SUBJECT: AMENDMENT NOS.142 AND129 TO FACILITY OPERATING LICENSE NOS. DPR-58 AND DPR-74: (TAC NOS. 74198 AND 74199)

SUBJECT: AMENDMENT NOS.142 AND 129TO FACILITY OPERATING LICENSE NOS. DPR-58 AND DPR-74: (TAC NOS. 74198 AND 74199)

DONALD C. COOK NUCLEAR PLANT, UNIT NO. 1

SAFETY EVALUATION BY THE OFFICE OF NUCLEAR REACTOR REGULATION RELATED TO AMENDMENT NO. 142TO FACILITY OPERATING LICENSE NO. DPR-58 AND AMENDMENT NO.129 TO FACILITY OPERATING LICENSE NO. DPR-74

TABLE 4.4-4

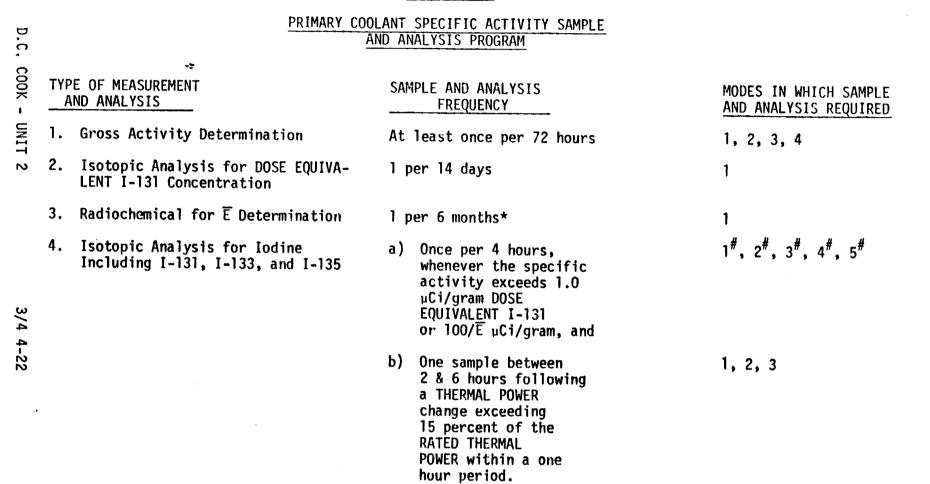
a. With the specific activity of the reactor coolant greater than 1 microCurie per gram DOSE EQUIVALENT I-131 or greater than $100/\overline{E}$ microCuries per gram, perform the sampling and analysis requirements of item 4a of Table 4.4-4 until the specific activity of the reactor coolant is restored to within its limits.

4.4.8 The specific activity of the reactor coolant shall be determined to be within the limits by performance of the sampling and analysis program of Table 4.4-4.
